# TECHNICAL SERVICE BULLETIN

NO.: BO007-96

MODEL: L-C

## FRONT DOOR BELT MOLDING WIND NOISE

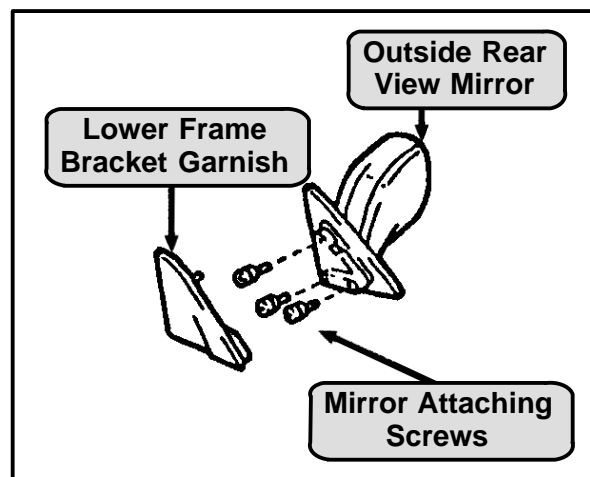
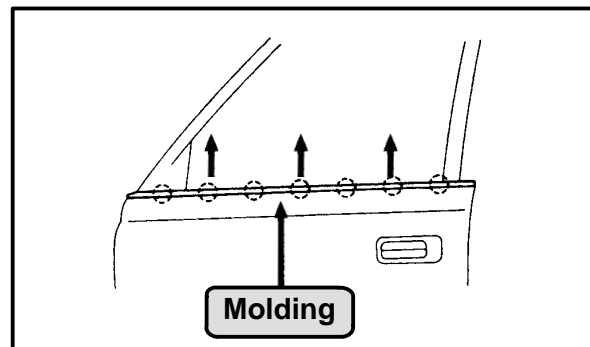
To prevent a high pitch wind flutter noise caused by air rushing between the front door belt molding and outer door skin area, foam-backed tape has been added to the back side of the molding.

- Lower door glass to bottom of travel.
- Remove "Lower Frame Bracket Garnish" (triangular plastic screw cover plate located inside the vehicle at base of mirror).
- Remove the 3 mirror attaching screws and carefully pull mirror away from door frame.

**NOTE:** Wrap door mirror with a shop towel and carefully drape door mirror against door.

- Remove belt molding attaching screw (located at rear inside edge of door frame).
- Grasp molding with 2 hands and pull molding straight up using a swift upward motion.
- Use needle-nose pliers to remove plastic attaching clips that remained attached to metal door panel when molding was removed.

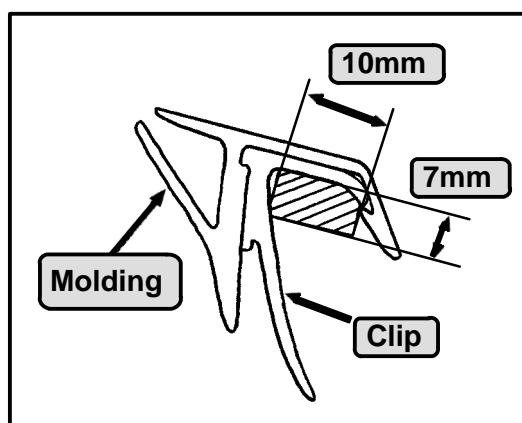
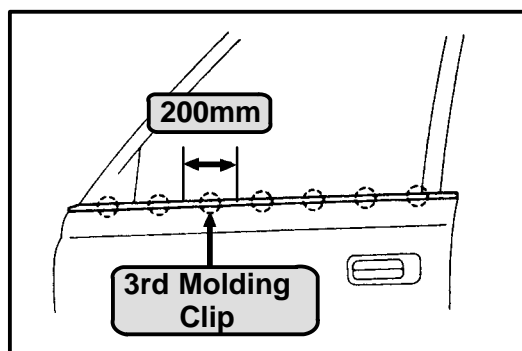
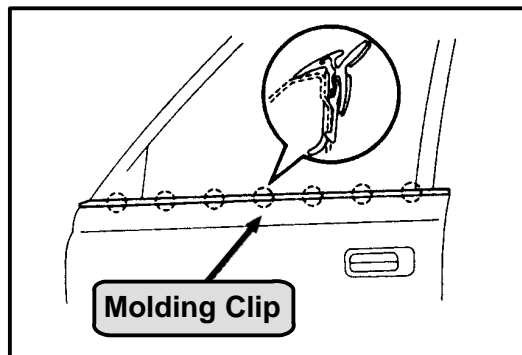
- Reinstall plastic attaching clips to back of belt molding.

**NOTE:** Place clips in the factory location. Original location is easily determined by the small scratch marks left on the back side of the molding by the clips.

- **Center** and adhere a piece of foam backed tape (from the Toyota Squeak and Rattle Kit, P/N 08231-00801) to the back side of the molding, directly over the third clip (3rd clip counting from the front edge of the molding).

**NOTE:** Tape should be approximately 10 mm wide X 7 mm thick X 200 mm long.
